Here are my design rules for the rigid-flex PCB. They are acceptable for current manufacturing capabilities.

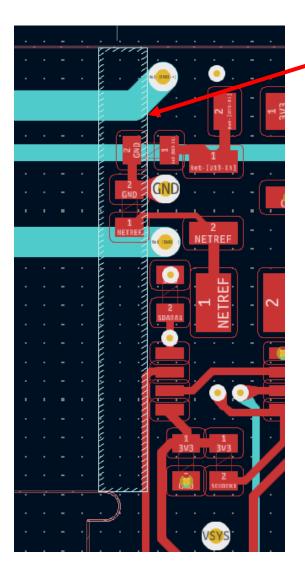
1 - Rule Areas were defined for each rigid-to-flex transition with a minimum width of 50mils. This is where the 50mils from rigid edge is important for the rigid-flex manufacturing process to meet Class 3.

In KiCAD, I setup the rule area for inner layers L3 thru L6. This way, blind vias L1-L2 and L7-L8 are still permitted in the area. The issue has to do with the adhesive for the flex coverlay expanding during solder reflow and potentially creating a latent defective crack in the feedthrough.

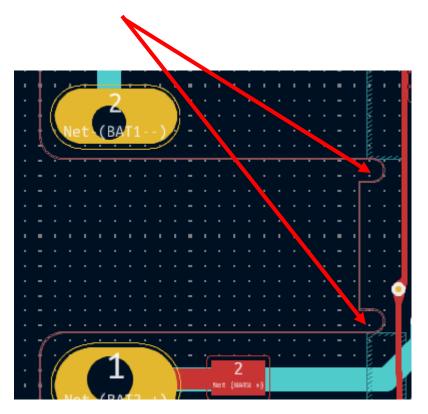
2 – There needs to be stress-relief at the flex layer transition corners. The board edge cut was changed to provide the stress-relief.
